Technical Service Bulletin: TSB220146

New Fuel Pump Oil Supply Line

Description of Change

Figure 1, New Oil Supply Line Kit Parts Breakdown.

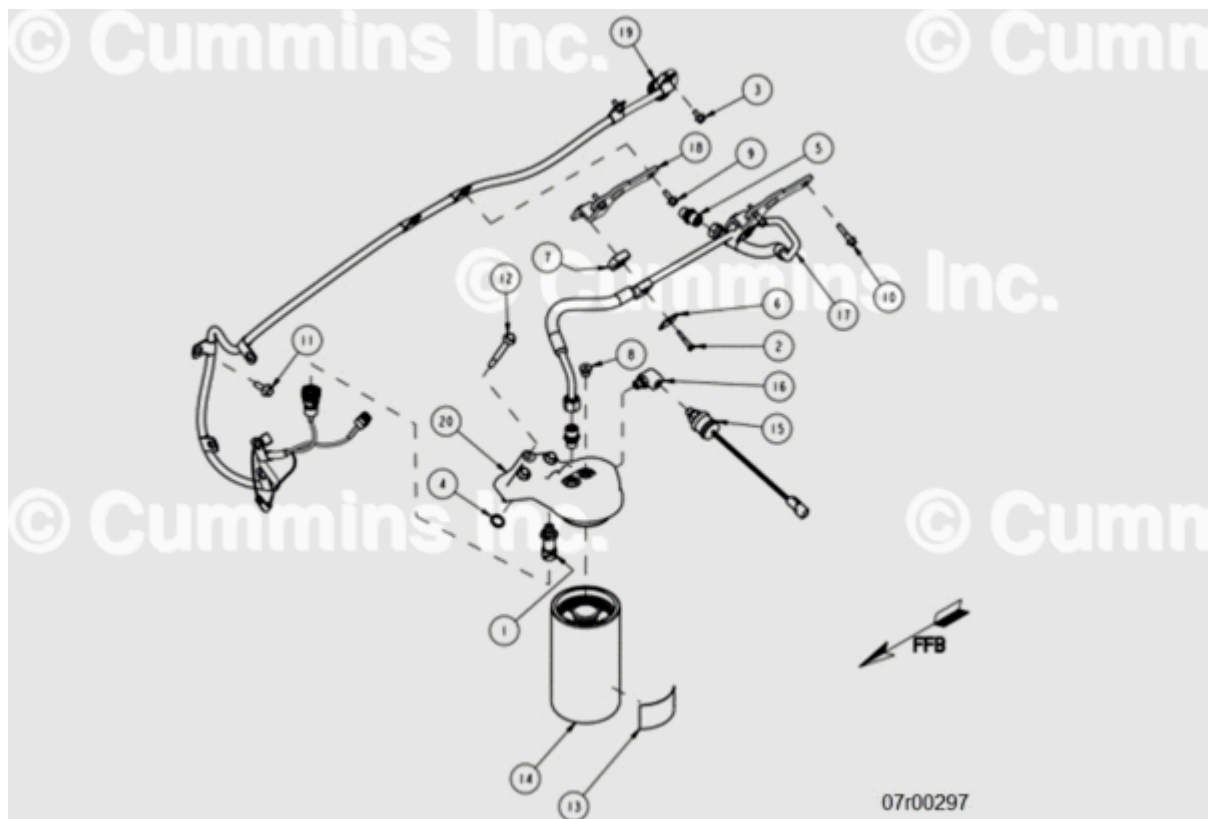
A new oil supply line has been developed for the modular common rail system fuel pump. The new oil supply line increases the oil pressure available to the fuel pump and improves the reliability and component life.

There have been reports of fuel pump fault codes relating to low oil and fuel pressure. To improve reliability, a new oil supply line has been released that increases the pressure of oil available to the fuel pump by feeding oil directly from the main oil rifle to the fuel pump accessory drive.

Figure 2, New Cylinder Block Supplied Oil Supply Line.

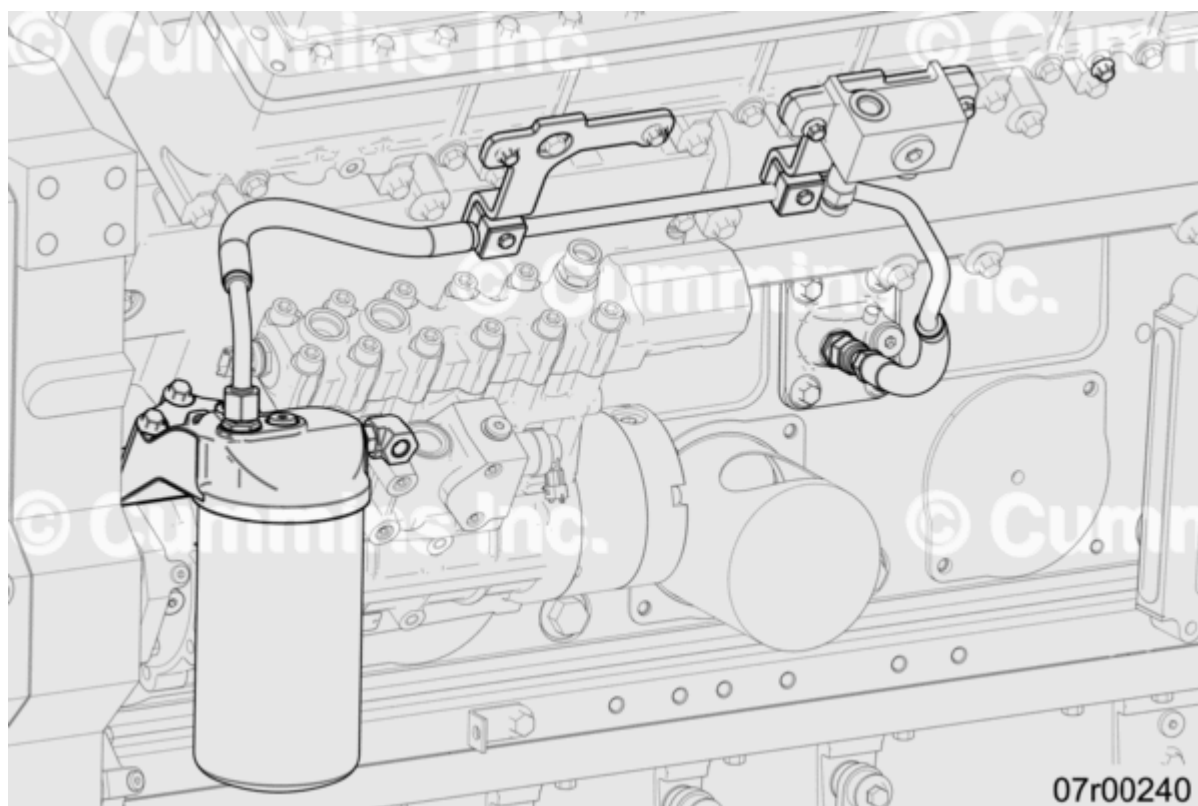
The new cylinder block supplied oil supply line can be identified by the supply point being a main oil rifle connection. See Figure 2 below.
